UNITED STATES PATENT AND TRADEMARK OFFICE

APPLICATION NO.	FILING DATE	FIRST NAMED INVENTOR	ATTORNEY DOCKET NO.	CONFIRMATION NO.
09/558,279	04/25/2000	Stephen Hollock	THOR-0002	8924

Office Action Summary

DETAILED ACTION

Figure 1 - U.S. Patent 5,677,529 to Hofmann et al.

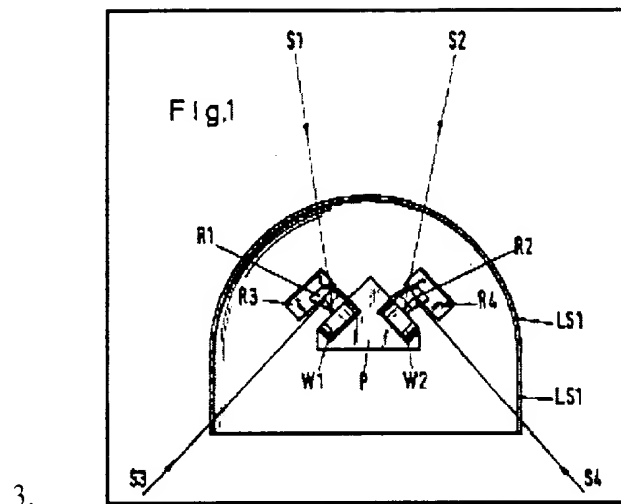
4. As per claim 1, Hofmann et al. disclose an apparatus comprising:

5. a) a detector (**W1**) and lens (**LS1**) to define a first field of view (**S1**) of the apparatus and to provide a single image of a distant scene on the array;

6. b) a reflector (**R1**, **R3**) arranged between the plane of the detector and the plane of the lens to define a second field of view (**S3**) which extends beyond the first field of view (**S1**) and to reflect onto the detector radiation entering the lens from outside the first field of view.

7. Hofmann et al. do not explicitly disclose an apparatus comprising a detector array.

8. It would have been obvious to modify the apparatus of Hofmann et al. such that it incorporated a detector array. One would have been motivated to make such a modification, based on a common sense understanding of radiation sensing, that a detector possessing a plurality of sensing elements (detector array) is able to provide high-resolution detail of a scene of interest.
